Offshore Special Regulations – 3.11 Sheet Winches

Interpretation 02-2022 Offshore Special Regulations

Effective date: 16/11/2022

Figure 1

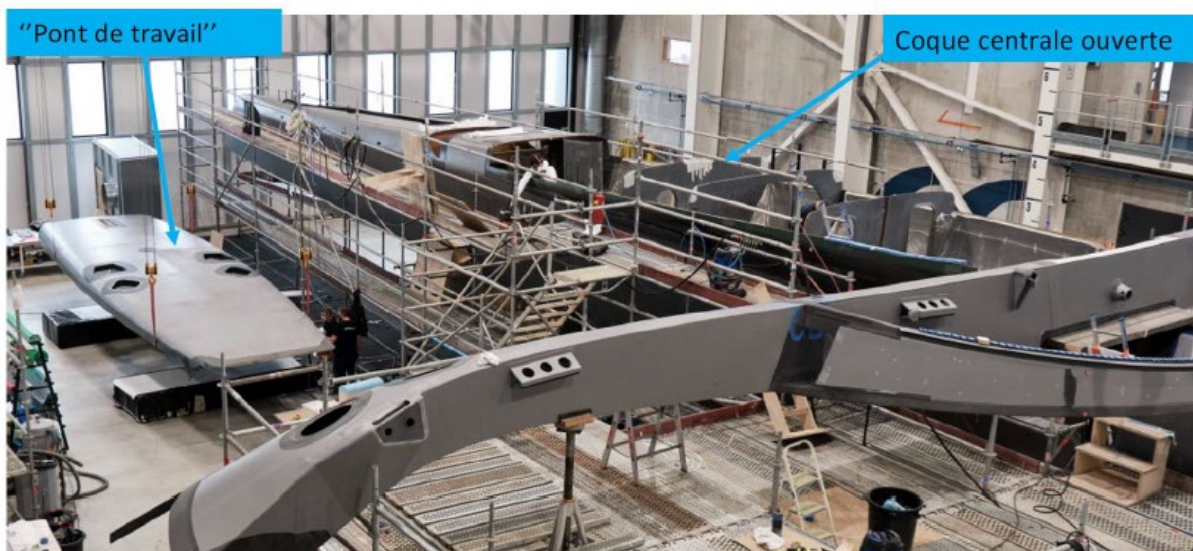
1. *In this example of layout, would the component marked “pont de travail” be considered to be deck?*

2. *If the answer to Question 1 is “yes” could any part of this component be considered not to be deck?*

3. *If the answer to Question 1 is “yes”, does this example of cockpit layout comply with OSR 3.11?*

Yes.

No. However, other parts of OSR, such as 3.07 must also be considered with regards to the assembly of this part.

No.
